**REPORT TO THE SUBDIVISION AND  
DEVELOPMENT APPEAL BOARD**

<b>DATE:</b> <del>April 29, 2021</del> ; July 8, 2021	<b>APPEAL NO.:</b> SDAB2021-0028 <b>FILE NO.:</b> SB2020-0029
<b>APPEAL BY:</b> Deer Trail Development Inc. and Maidment Land Surveys Ltd., represented by Robert Homersham	
<b>FROM A DECISION OF THE SUBDIVISION AUTHORITY</b> where a subdivision  was refused at  <u>882 77 Street SW:</u> <u>PLAN 0210368; BLOCK D; LOT 22</u>	<b>LAND USE DESIGNATION:</b> R-1s
<b>COMMUNITY OF:</b> West Springs	<b>DATE OF DECISION:</b> March 16, 2021
<b>APPLICANTS:</b> Deer Trail Development Inc. and Maidment Land Surveys Ltd., rep. by Robert Homersham	<b>OWNER:</b> Deer Trail Development Inc., represented by Robert Homersham

## Reasons for Refusal – Subdivision by Plan

**CITY OF CALGARY**  
**TENTATIVE PLAN SHOWING SURVEY OF**  
**PROPOSED BARE LAND CONDOMINIUM**  
**AFFECTING**  
**LOT 22, BLOCK D, PLAN 021 0368**  
**WITHIN THE**  
**N.E.1/4 SEC.22, TWP.24, RGE.2, W.5M.**  
**SCALE: 1: 300**  
**B.M. WILSON, ALS 2020**

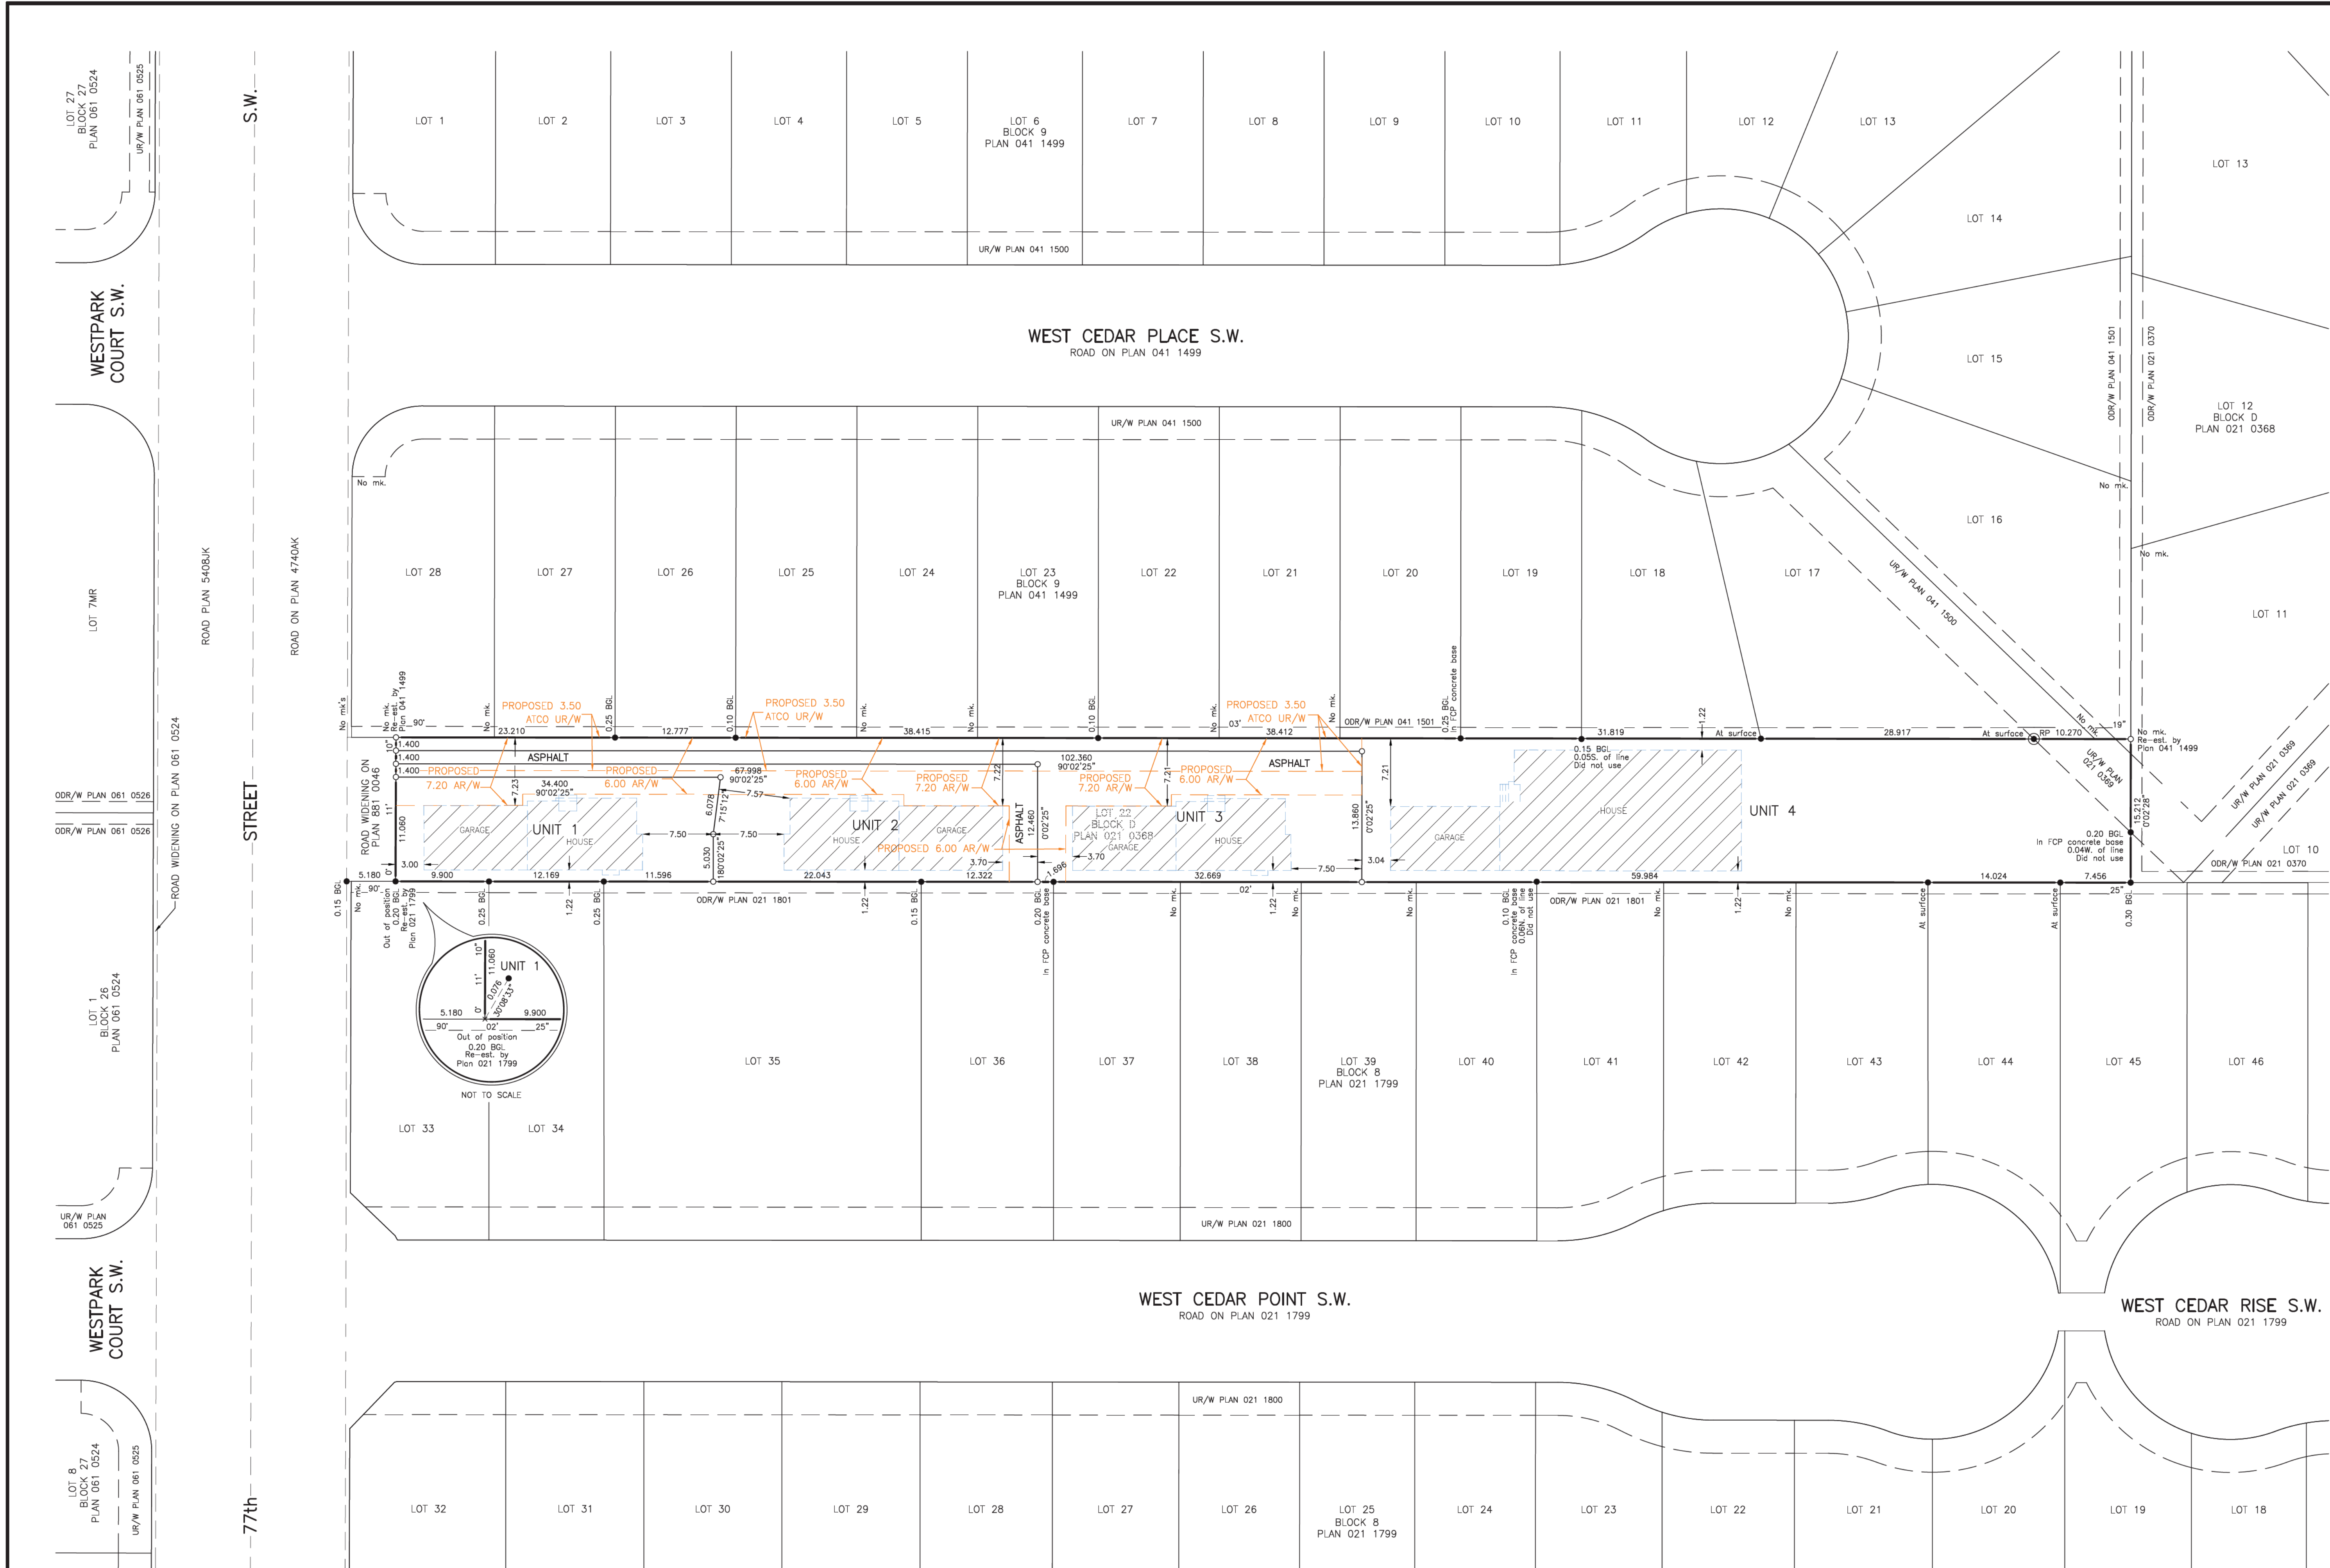
The Subdivision Authority is primarily concerned with the following:

1. The proposed lotting pattern is out of character with the surrounding area.
2. The proposed access easements will limit the practical use of the proposed lots, in that unimpeded access to the right-of-way will be required at all times. This means there will be no parking area for visitors, service vehicles, etc.
3. In the event that the utilities within the proposed utility right-of-way/access right-of-way need to be excavated, vehicular egress and ingress would be severely impeded.

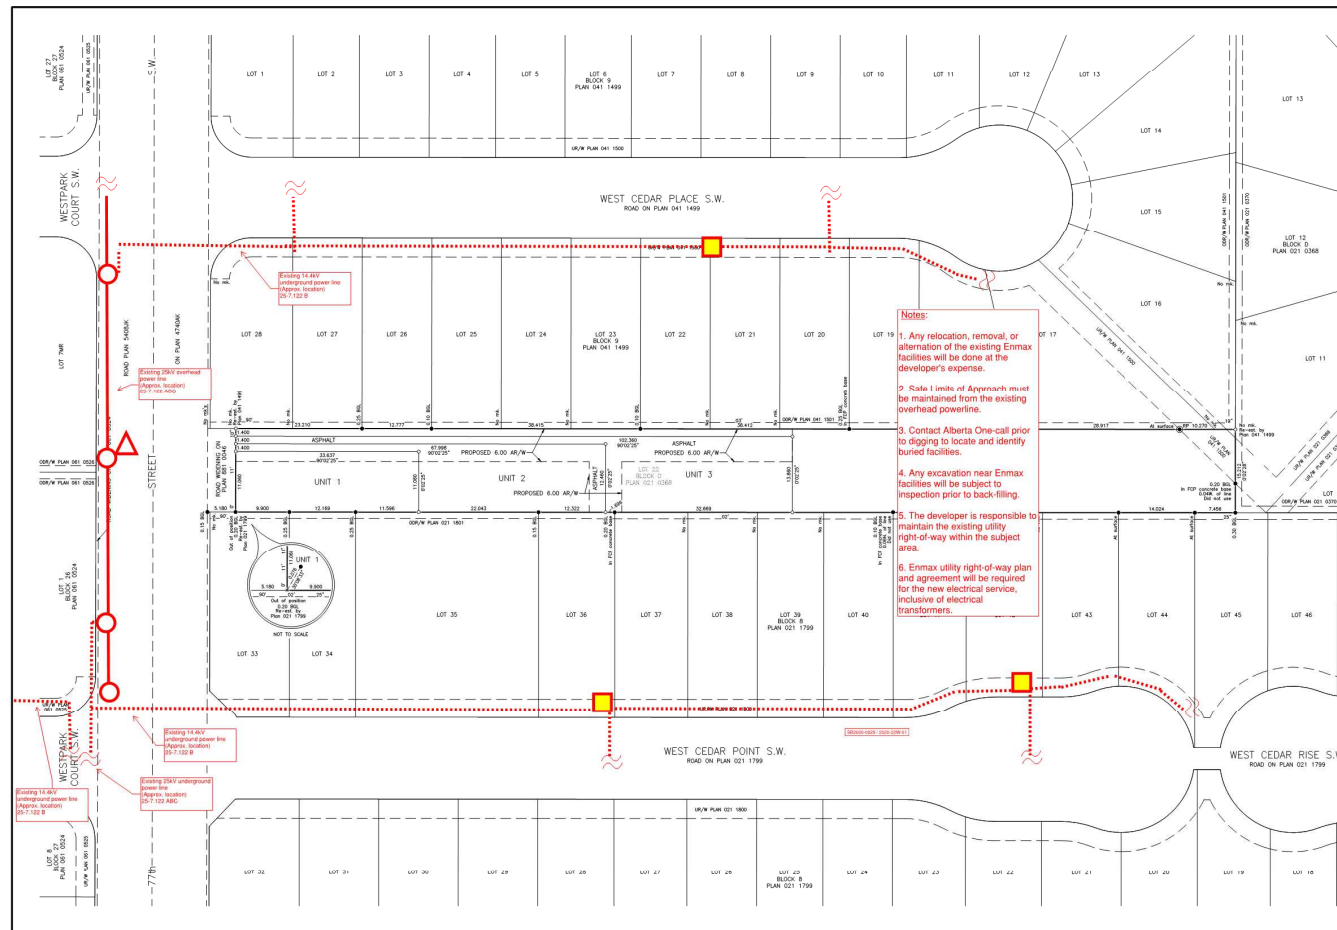
1. There is an existing 25 kV three-phase overhead power line installed along the 77 ST SW, outside the west limit of the subject area (as approximately shown on the attached plan. Any revision, relocation, or alteration of the existing overhead power line will be done at the developer's expense.

2. Anyone working near the above-mentioned overhead power line must maintain Safe Limits of Approach in accordance with the Alberta Electrical and Communication Utility Code, Table 1 (i.e. minimum 3.0m).

SKETCH SHOWING  
PARCEL WIDTHS & DEPTHS BASED UPON  
LAND USE BYLAW 1P2007

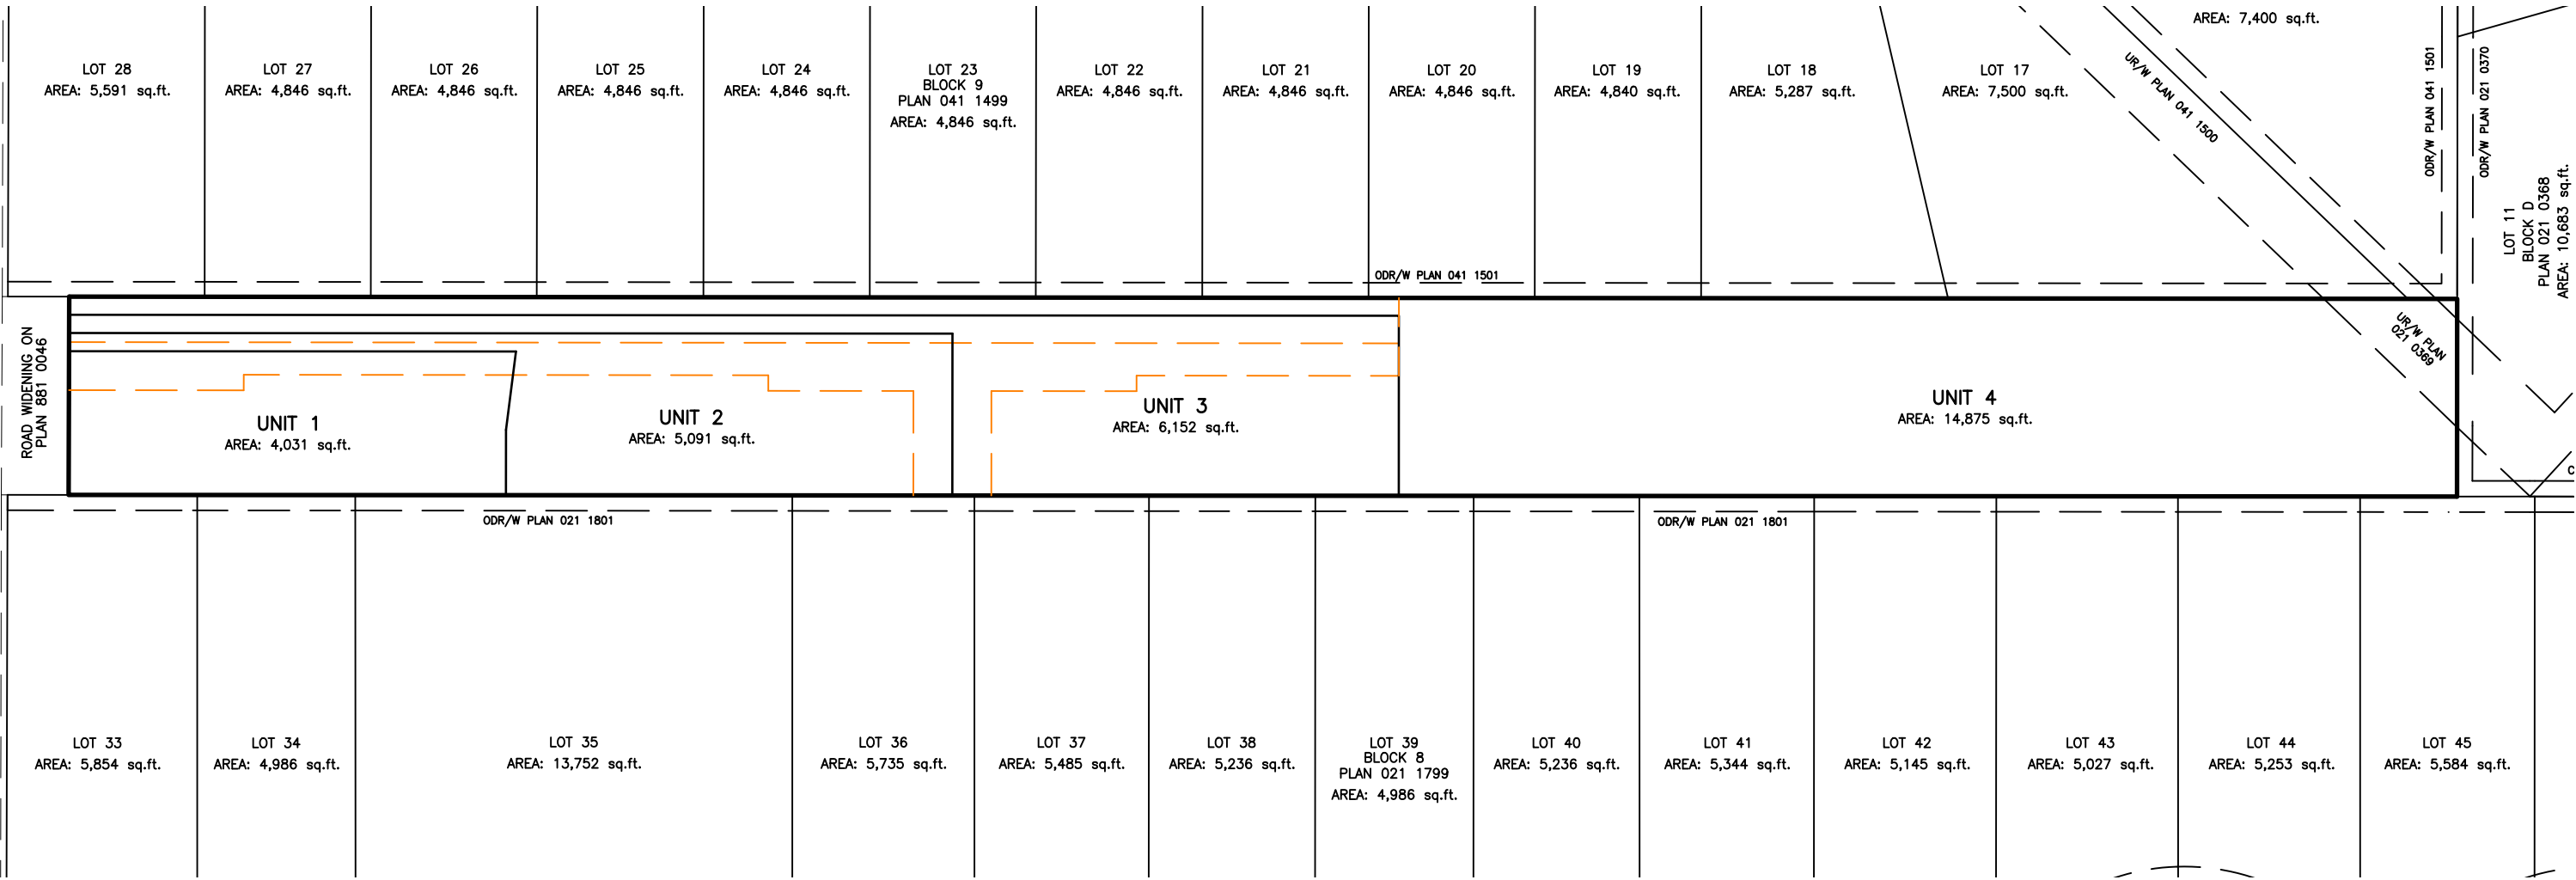
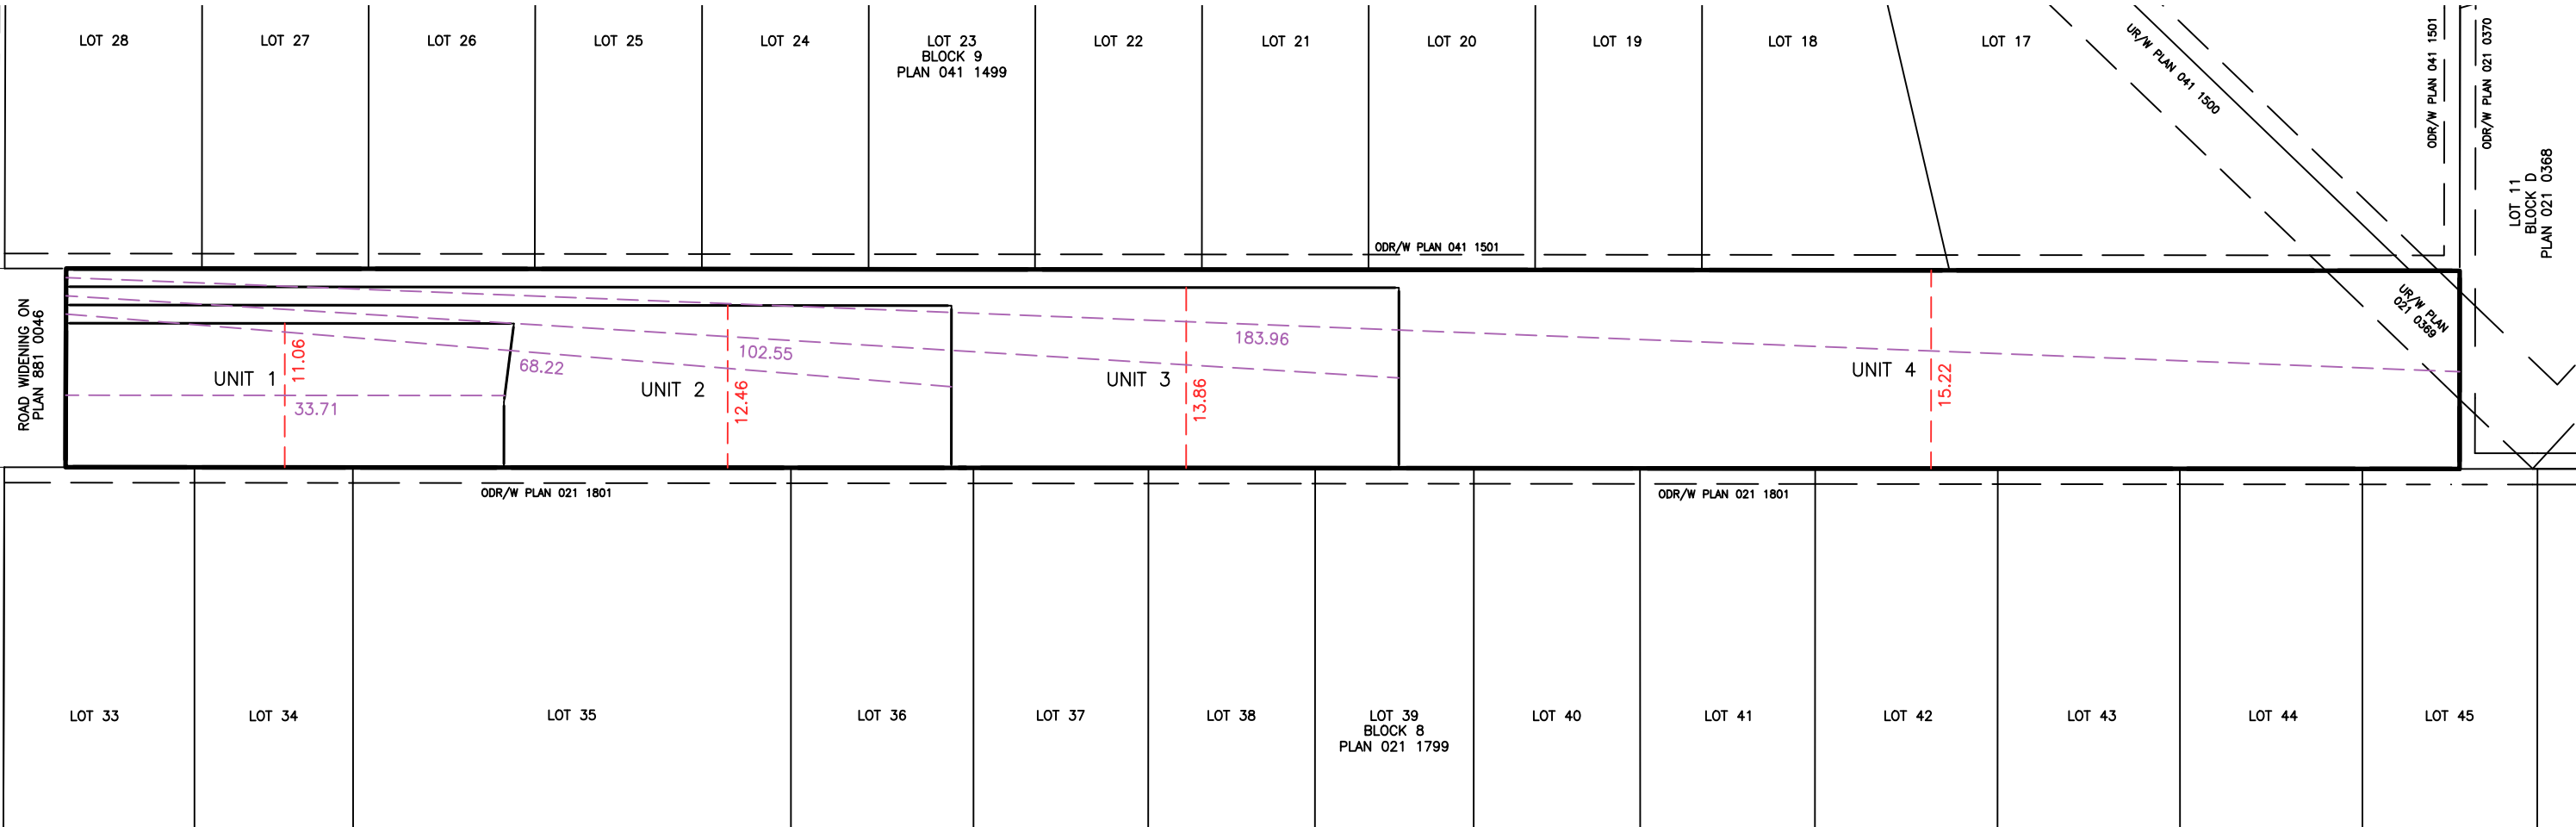
Unit 2 building has been 'flipped' and relocated on the parcel.
